**Glen Eira Planning Scheme Amendment C237glen
Carnegie Structure Plan**

Panel Report

28 March 2024

Panel Report pursuant to section 25 of the PE Act

Figure 2 Structure Plan and Activity Centre boundaries

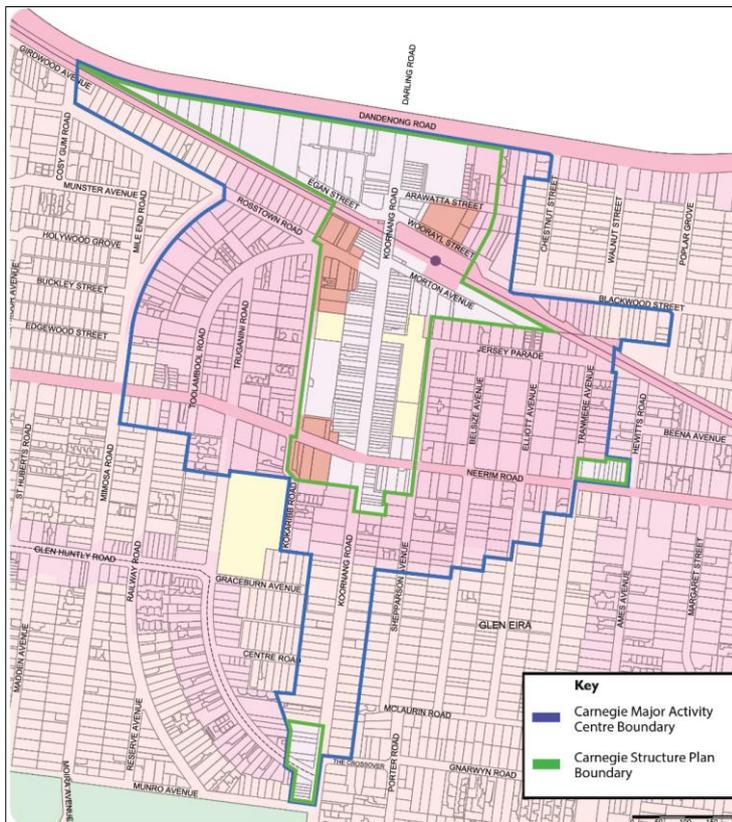
- it is unclear how the Structure Plan boundary was determined, particularly along the Carnegie Motor Inn site and part way through a city block
- the Structure Plan boundary should be realigned to include 36 and 38 Woorayl Street (both are in the Carnegie Major Activity Centre boundary) because this would:
 - increase residential and commercial space and populations
 - increase revenue to Council and the community
 - reduce conflict arising from owners seeking to rezone their properties in future.

Eight submissions requested that Chestnut Street properties be included in the Activity Centre and to remove the Neighbourhood Character Overlay from those properties.

The Panel does not support realigning the Activity Centre boundary or revising planning provisions affecting Chestnut Street properties through the Amendment. Such changes are beyond the scope of the Amendment and should be proposed with appropriate notice and review.

- The Structure Plan and Activity Centre boundaries are appropriate.
- Chestnut Street properties should not be included in the Activity Centre through the Amendment and therefore the existing zone and overlays should continue to apply.
- Council should consider reviewing through a separate process whether maintaining the neighbourhood character of Chestnut Street properties outweighs policy seeking more housing and economic development close to a major activity centre and train station.

Figure 3 Building envelopes to meet mandatory overshadowing requirements

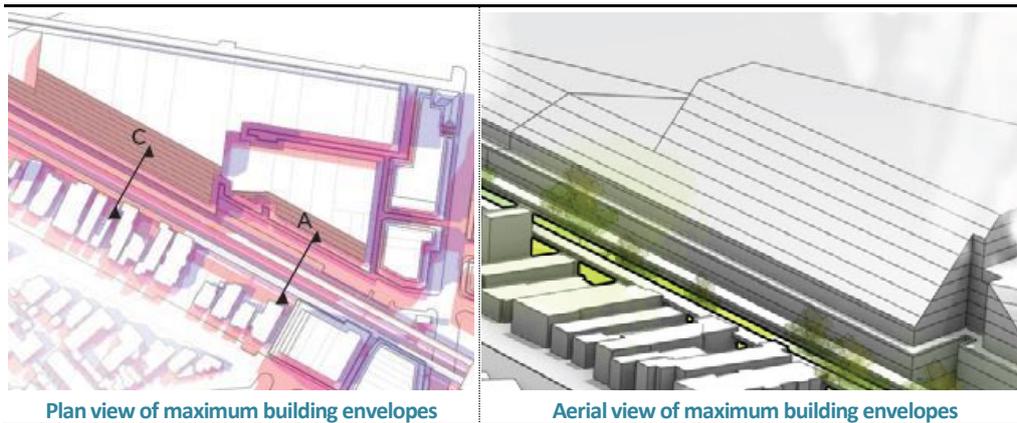
Ms Roberts referred to images in the Built Form Framework (Figure 3) which show how built form needs to be managed to protect solar access to adjoining open spaces. She noted the final built form would be broken up by towers to achieve habitable and constructable floorplates.

- The Djerring Trail shadow studies do not depict 'existing conditions' as stated, as they show the proposed DDO9 massing and ignore existing built form west of Egan Street that exceed the DDO9 form;

- The Djerring Trail shadow studies do not appear to show the entirety of the Djerring Trail open space (as defined by Map 03 of the Day 3 DDO9), with the western section omitted;

- Both the Djerring Trail and Woorayl Reserve shadow studies continue to fail to distinguish between the vastly different functions of different areas within the POS (e.g., they don't show the actual Djerring Trail as opposed to the adjacent drainage and inaccessible garden areas).

Figure 6 Library forecourt – Jersey Parade Reserve, Open space north of the library and Neerim Road Open Space – map and overshadowing diagrams

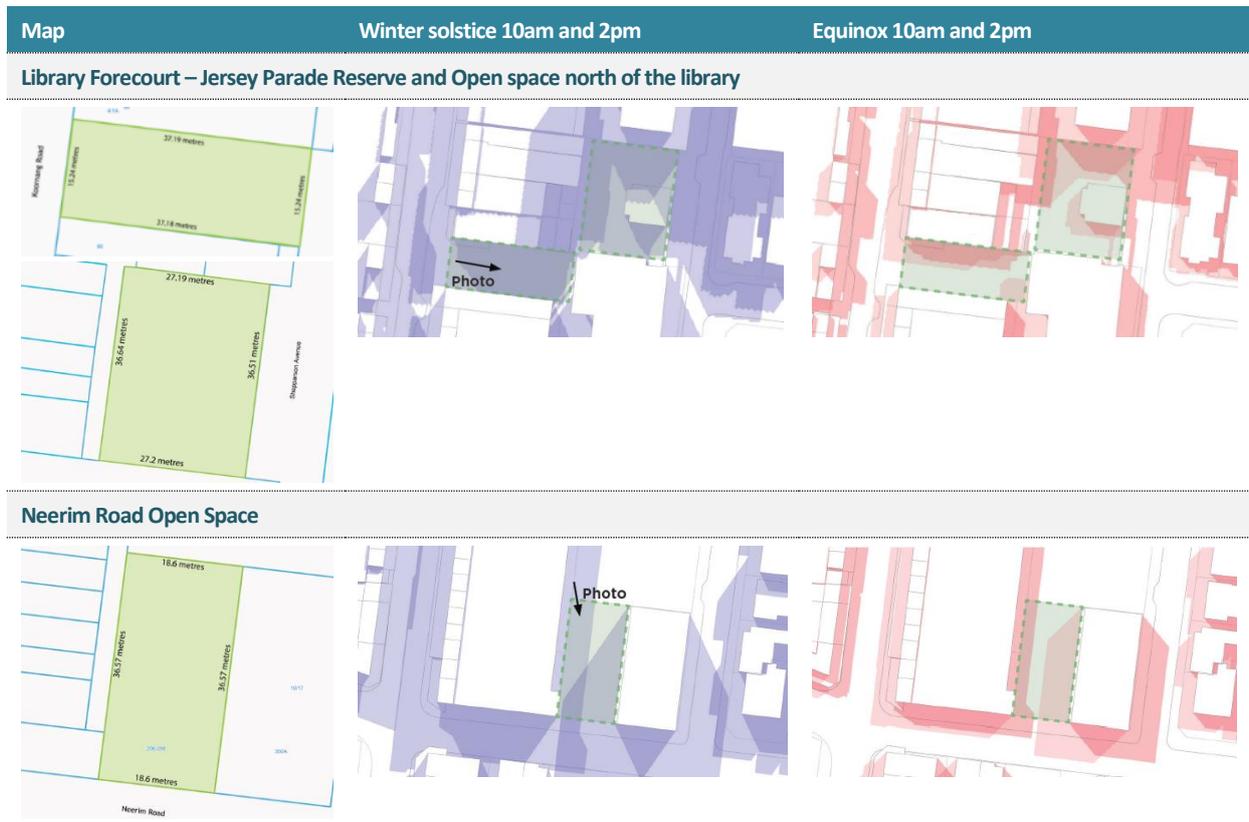
The issues are whether the proposed mandatory DDO9 overshadowing requirements are appropriate for the Library Forecourt - Jersey Parade Reserve (winter solstice), Open space north of the library (equinox) and Neerim Road open space (equinox).

Figure 10 Exhibited DDO9 interface types (Exhibited and final version)

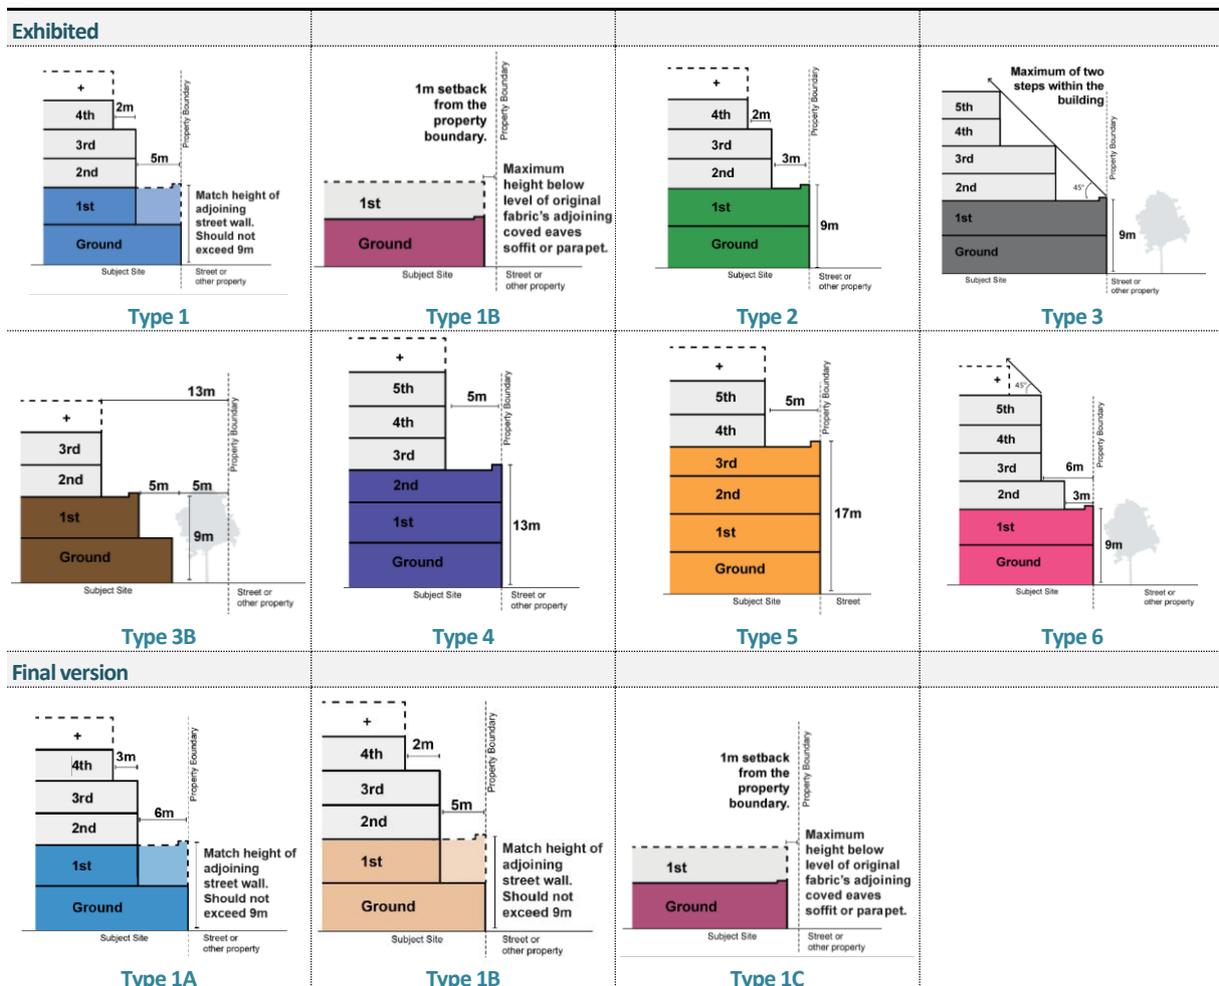
Interface Type 1B is not appropriate for Precinct 3 properties north of the skyrail because it seeks a lower scale response which would never achieve a consistent streetscape at this location because of existing and relatively recent larger scale and inconsistent built form.

- recognise the emerging character of this location
- will continue to achieve Structure Plan objectives
- will enable a transitional and complementary street wall between existing larger built form and the small group of heritage buildings on the east side
- will not negatively impact the small group of heritage building on the east side.

- l) **on Map 2, replace Interface Type 1 with Interface Type 1A for land in the Heritage Overlay (HO158) and Heritage Overlay (HO159)**
 - m) **in Table 2 (Building setbacks and street wall heights) and associated diagrams replace Interface Type 1 with Interface Type 1A and:**

Figure 11 Structure Plan movement and parking plan extract

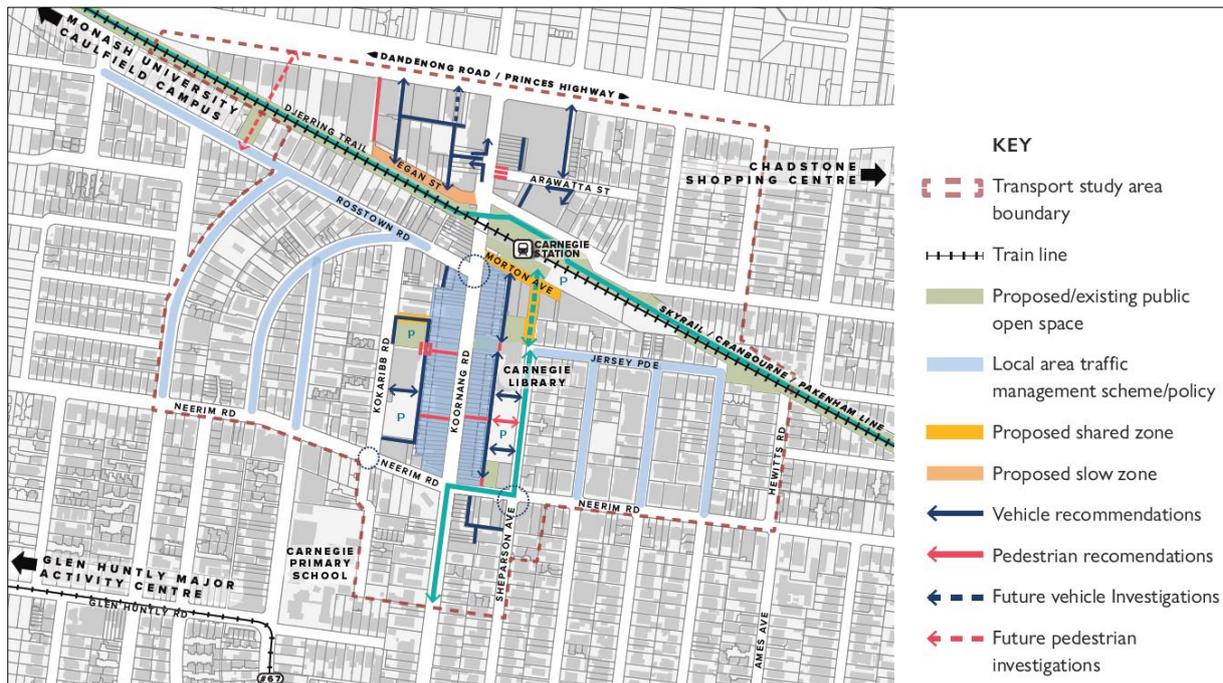
The term ‘vehicle recommendations’ is unclear and does not refer to a laneway. The Panel acknowledges that Structure Plan Figure 40 applies laneway categories – Vehicle recommendations, Pedestrian recommendations, Future vehicle investigations, and Future pedestrian investigations. However, these are also unclear.

- Structure Plan Figure 33 which applies the term ‘potential future pedestrian link’
- Structure Plan Figure 40 which differentiates between recommended movements on existing laneways and future laneway investigations
- their status in the Transport Study.

As a precautionary measure, Design and Development Overlay Schedule 9 Map 2 should identify and differentiate between retaining existing laneways for vehicle access and potential future laneways to be investigated for the same role. The laneway, transport and car park design requirements proposed since exhibition are generally appropriate but should be merged, simplified and revised in line with other Panel conclusions.

- s) revise Clause 2.9 laneway requirements (now Clause 2.6) to specify existing laneways and to identify locations where vehicle access is sought to be retained

Map 12 to Schedule 9 of Clause 43.02 - Building heights and interfaces

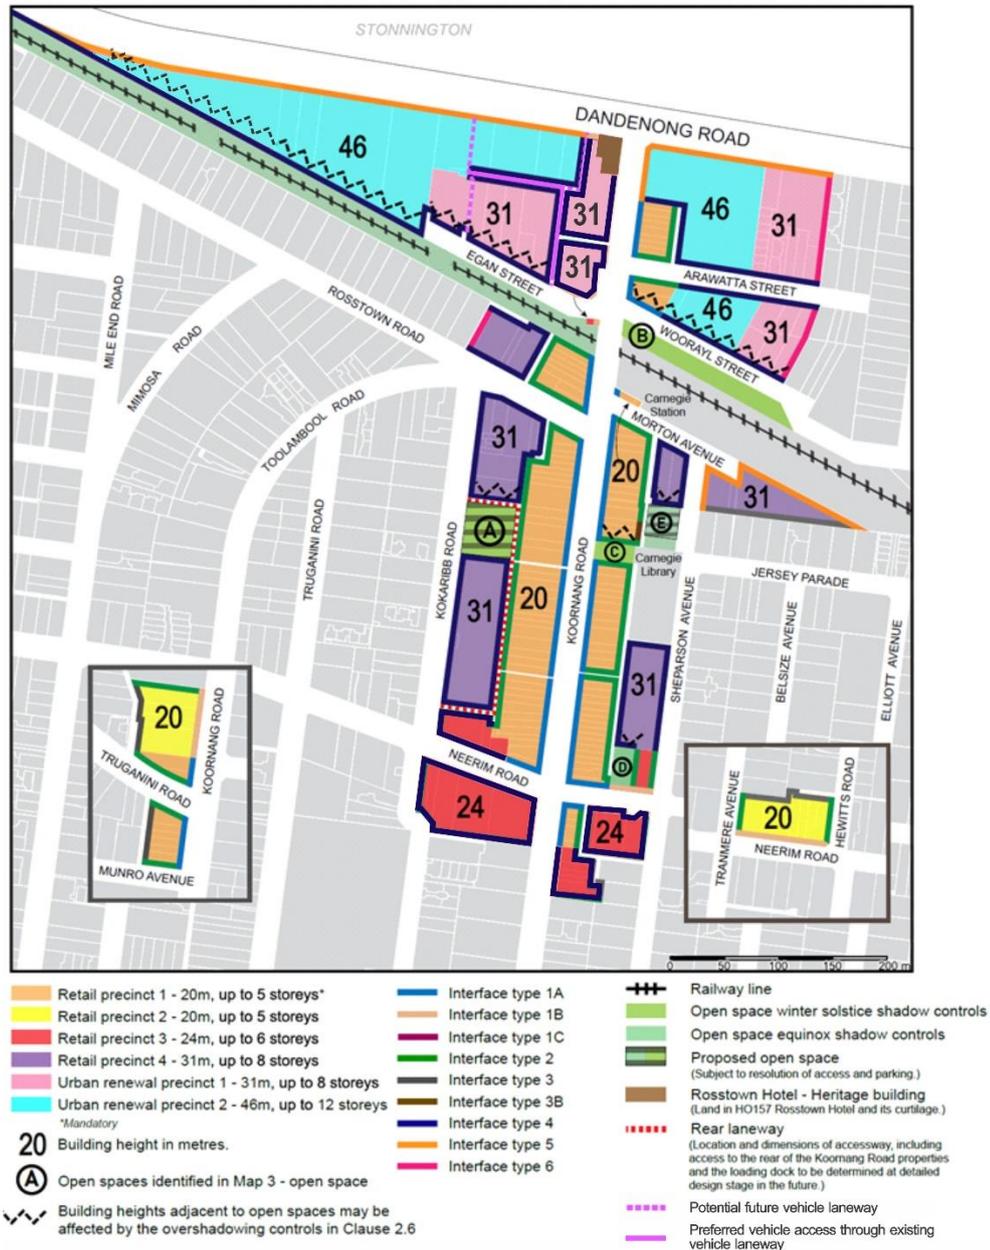
The pedestrian links should have been identified on Map 2 to understand whether they relate only to those shown in Figure 12 of the Structure Plan. This is needed because other figures and content in the Structure Plan refer to ‘pedestrian only lanes’, ‘pedestrian recommendations’ and ‘pedestrian connections’ to a larger number of paths including those in Figure 12.
